Re: St. Lucie Plant Unit 1  
Docket No. 50-335  
Renewed Facility Operating License No. DPR-67

Response to NRC Reactor Systems Branch and Nuclear Performance Branch  
Request for Additional Information Regarding Extended Power Uprate License  
Amendment Request

**Response to  
NRC Reactor Systems Branch and  
Nuclear Performance and Code Branch  
Request for Additional Information  
Regarding Extended Power Uprate  
License Amendment Request**

### **Response to NRC Reactor Systems Branch and Nuclear Performance and Code Branch Request for Additional Information Regarding Extended Power Uprate License Amendment Request**

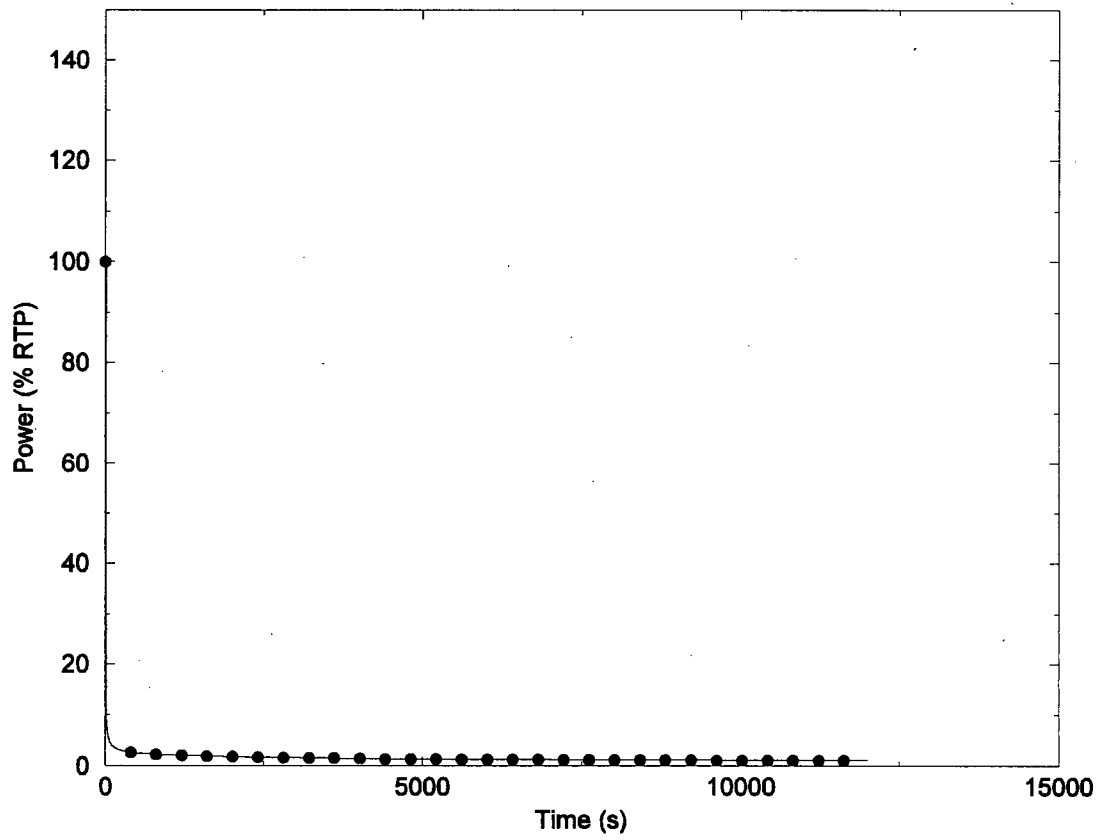
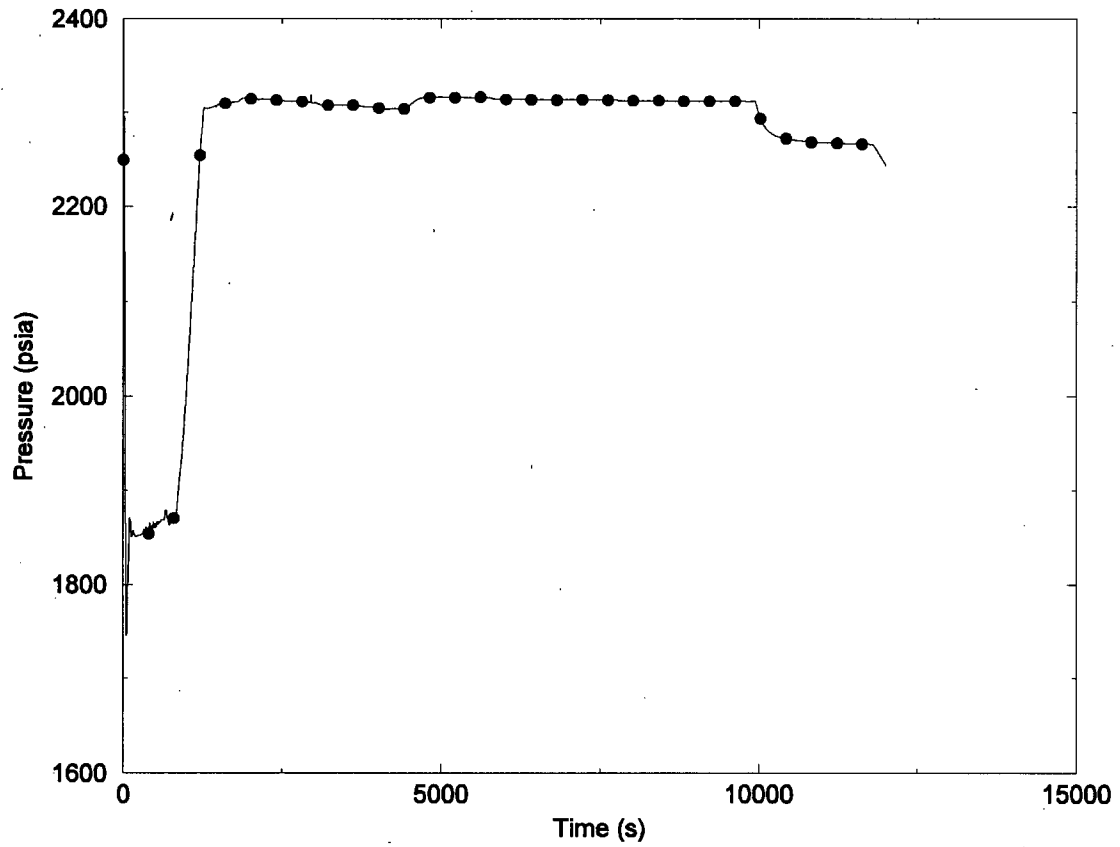
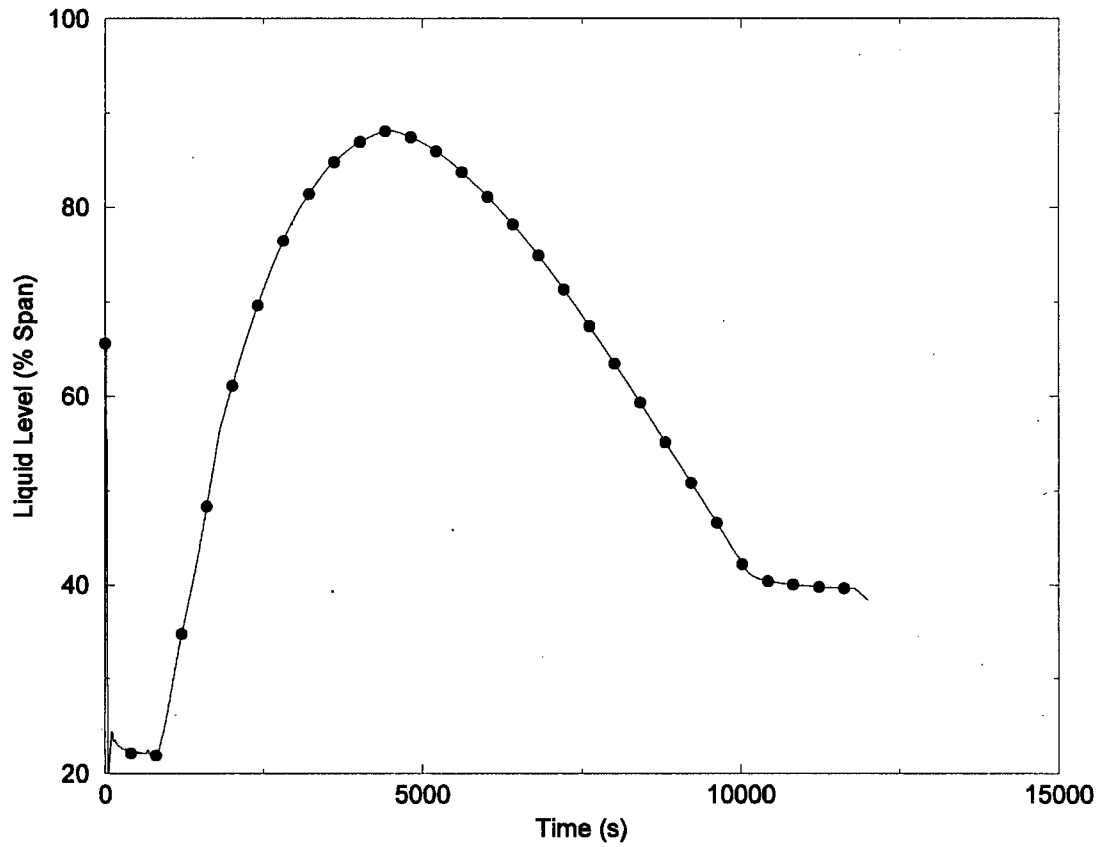
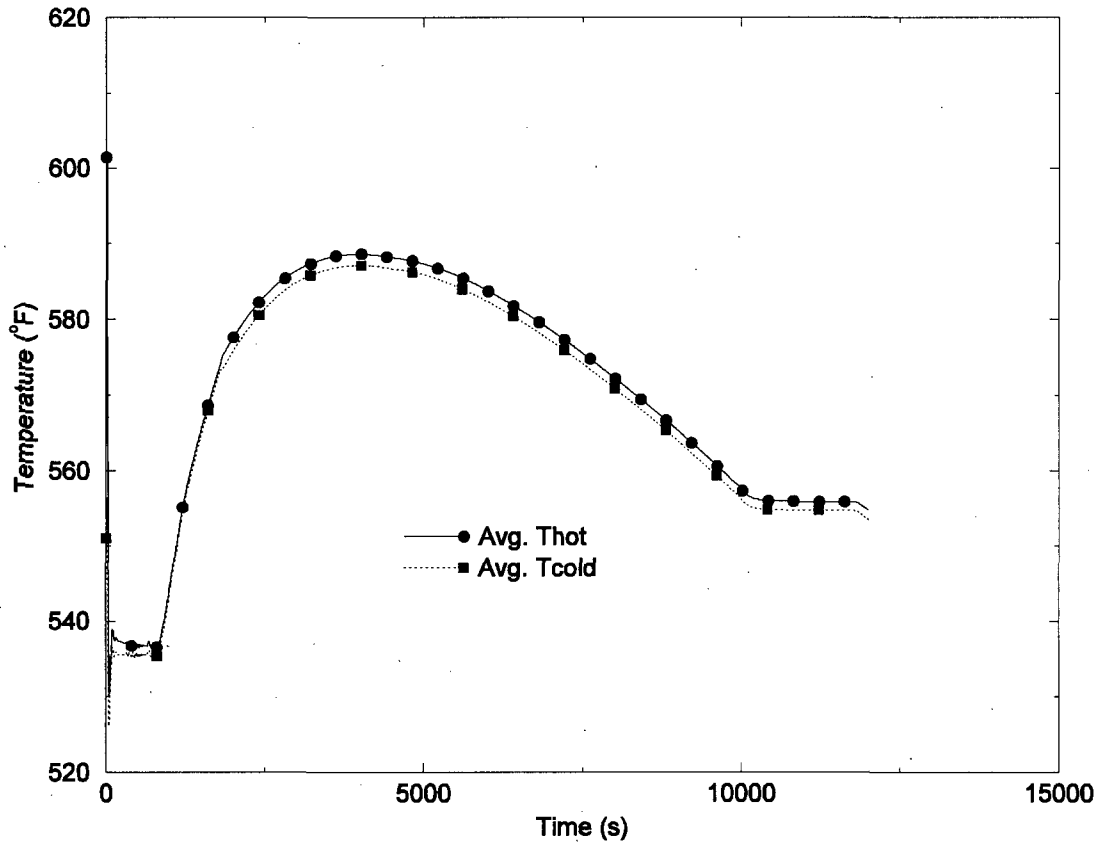
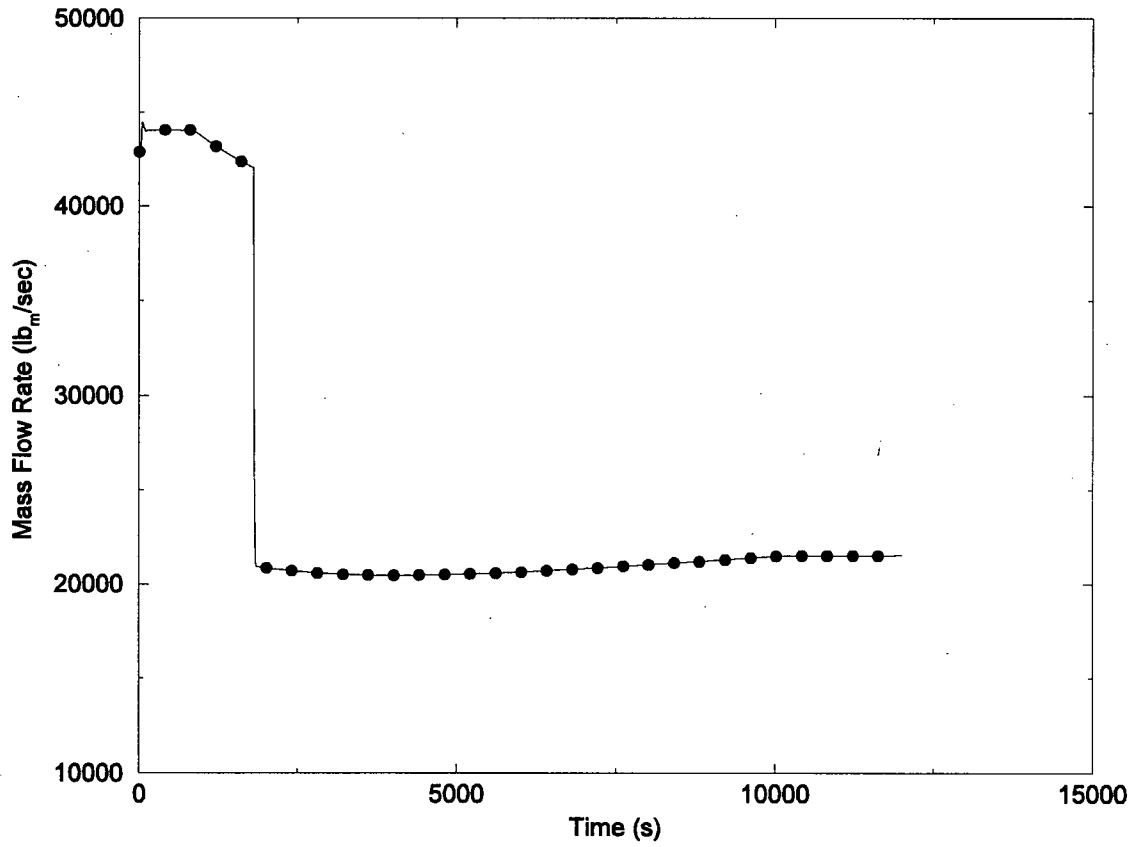
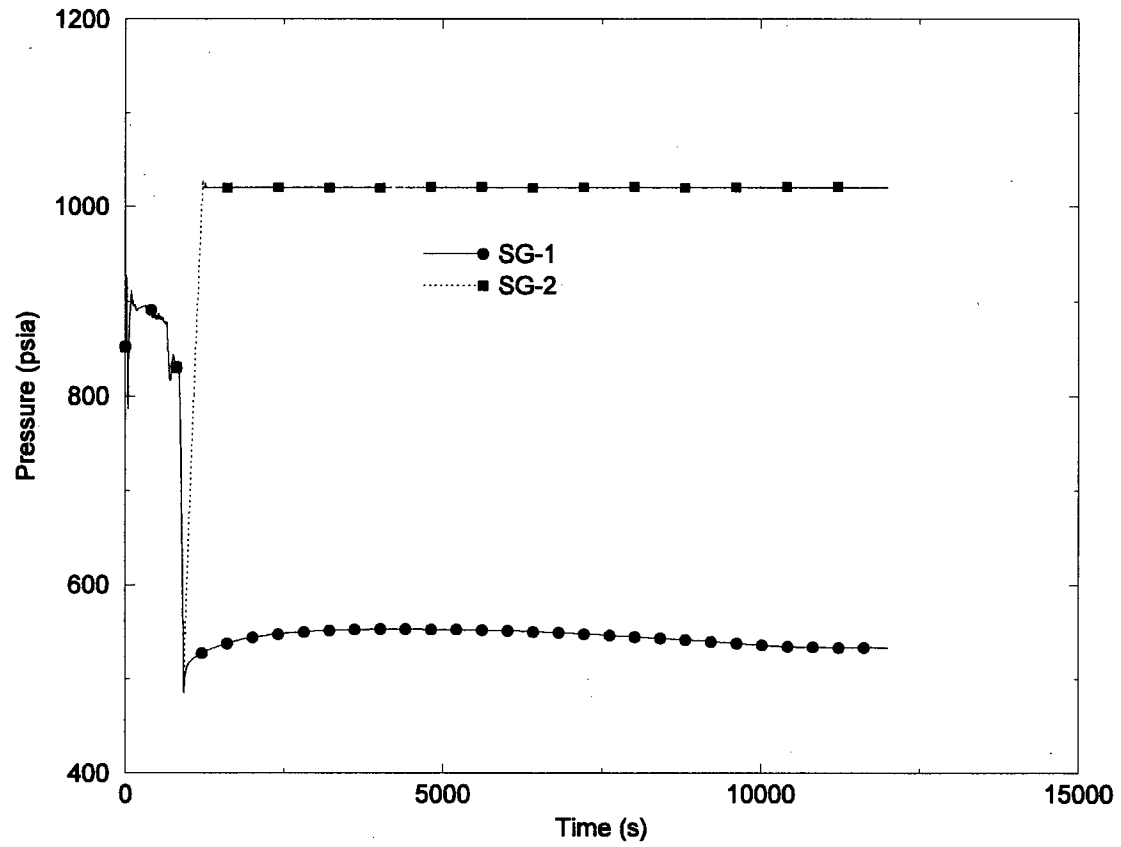
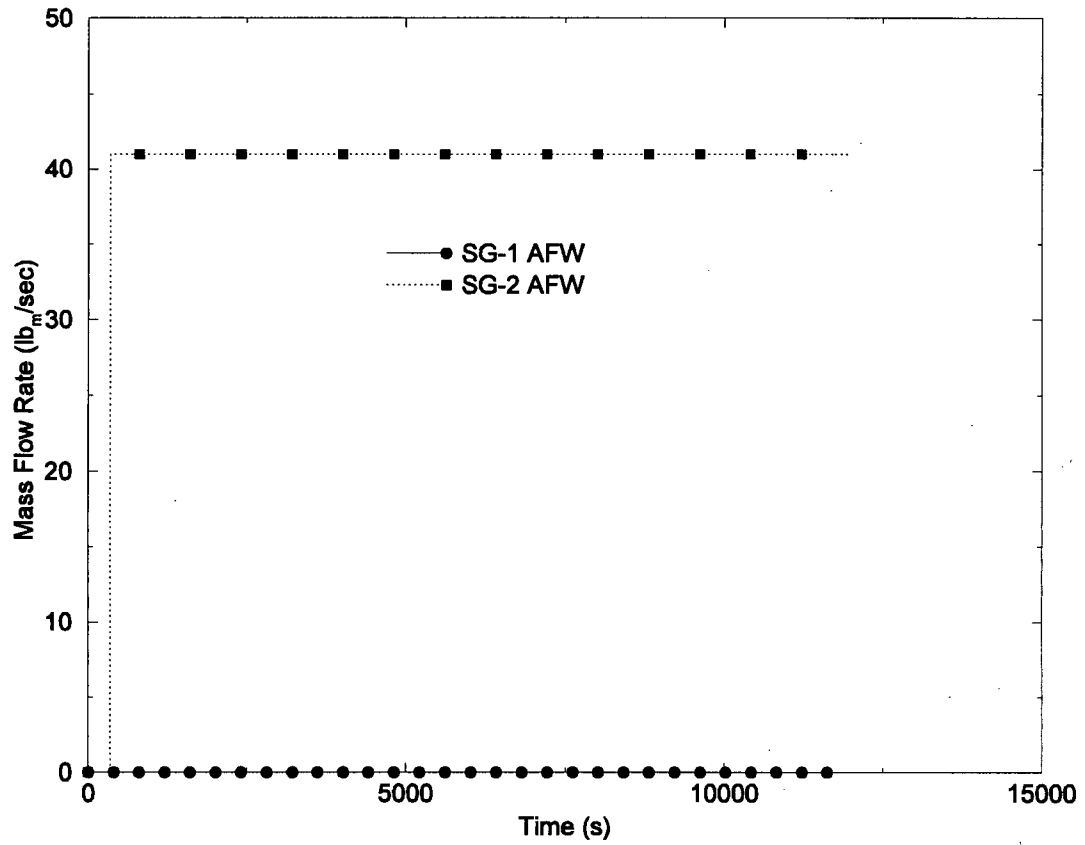
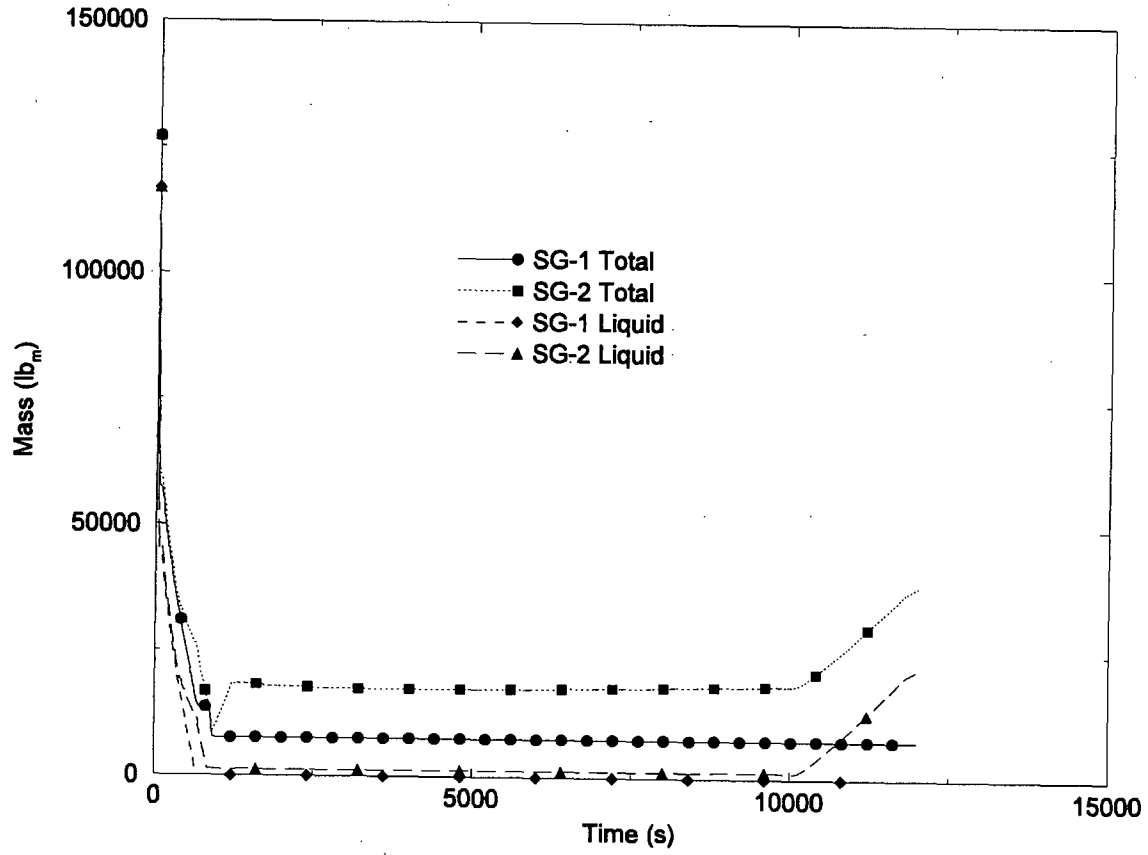
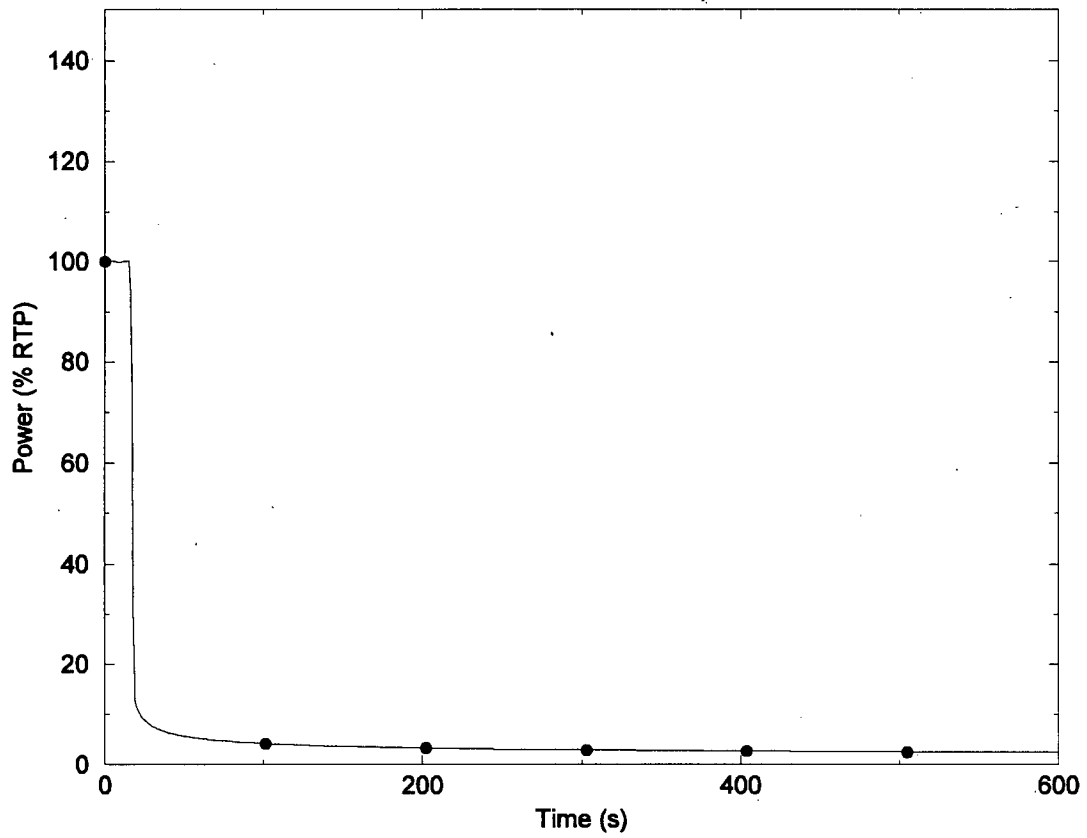
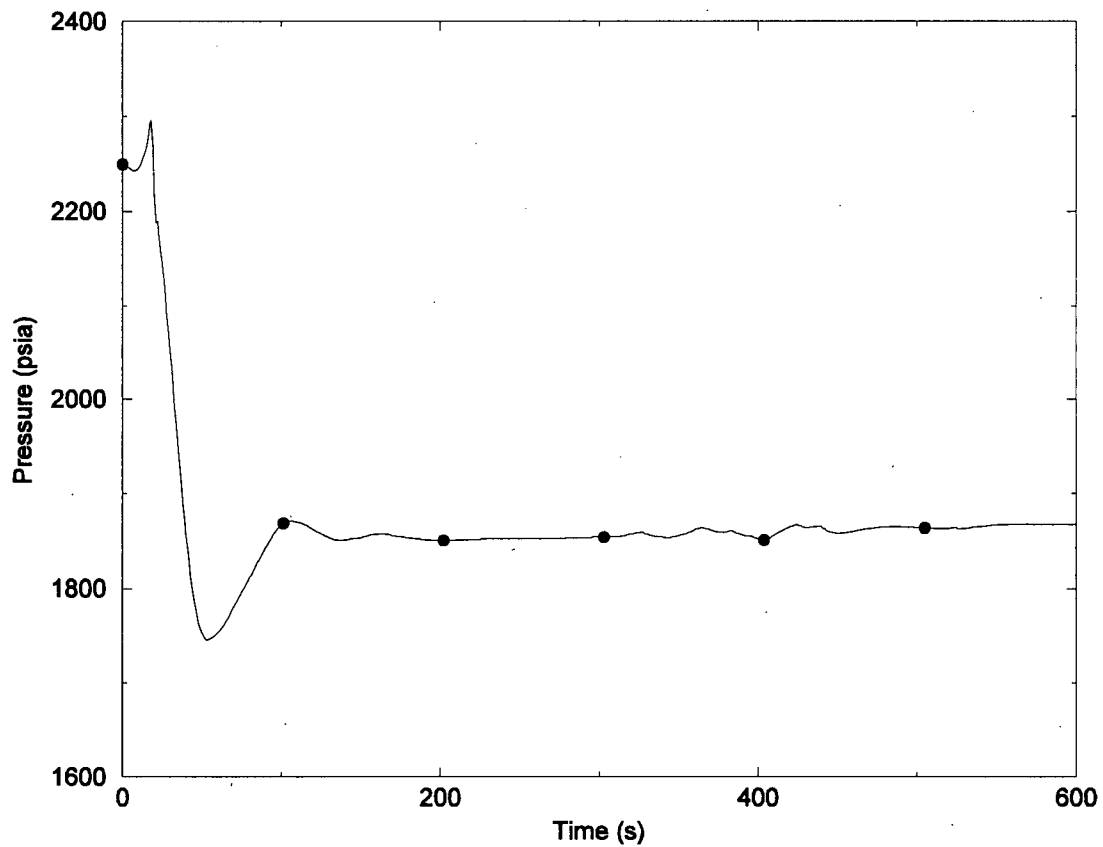
**[2.8.5.2.4.a] The LR states that, “in the St. Lucie Unit 1 licensing basis, the feedwater line break (FWLB) event is defined as a cooldown event that is bounded by the main steam line break (MSLB) event. The key system, subsequent to reactor trip, for mitigating the post-scrum MSLB event is the Safety Injection System, which injects boron into the RCS to arrest the post-scrum return-to-power (See LR Section 2.8.5.1.2). The same mitigating systems apply to both MSLB and FWLB.”**

**Defining the FWLB as a cooldown event eliminates the FWLB from consideration as a Condition IV design basis accident (DBA). When analyzed as a heatup event, the FWLB tests fuel and RCPB integrity, and helps set the performance requirements for the AFWS. The Safety Injection System, particularly its reactivity control function, does not mitigate the FWLB, when considered as a heatup event.**

**The FWLB is a limiting fault, in the “decrease in heat removal by the secondary system” category in Table 15-1 of RG 1.70. It is necessary to identify the FWLB as a limiting fault in the heatup category, and provide analyses of the worst cases in the current licensing basis, and in the LR that supports the proposed EPU.**

**According to the specific review criteria in SRP Section 15.2.8, and the guidance in Matrix 8 of RS-001, FWLBs are to be analyzed as heatup event. As such, FWLBs are in the class of events that are directly affected by an increase in authorized power level. The LR conclusion, that the plant will continue to meet the requirements of GDC 27 and GDC 35, following implementation of the proposed EPU, is not supported by analysis.**

**Provide an analysis of the FWLB, considered as a heatup event, according to the specific review criteria in SRP Section 15.2.8 and the guidance in Matrix 8 of RS-001.**

The results of this analysis are summarized in Table 3. The transient sequence of events is shown in Table 2, and the transient results are shown in Figure 1 to Figure 8. The results demonstrated that the degraded AFW system capacity and actuation setpoint are adequate to maintain primary-to-secondary heat transfer such that the plant can be stabilized and brought to a safe shutdown in a controlled manner. Adequate cooling was maintained through the vaporization of the AFW and the pressurizer steam space was preserved. There was no significant heatup of the primary system. Thus, all acceptance criteria are satisfied for this event.

The results of this analysis are summarized in Table 3. The transient sequence of events is shown in Table 2, and the transient results are shown in Figure 9 to Figure 16. With no automatic initiation of AFW flow, there is ample time (more than 10 minutes after event initiation) for the operators to start the turbine-driven AFW pump prior to losing subcooling margin and filling the pressurizer.
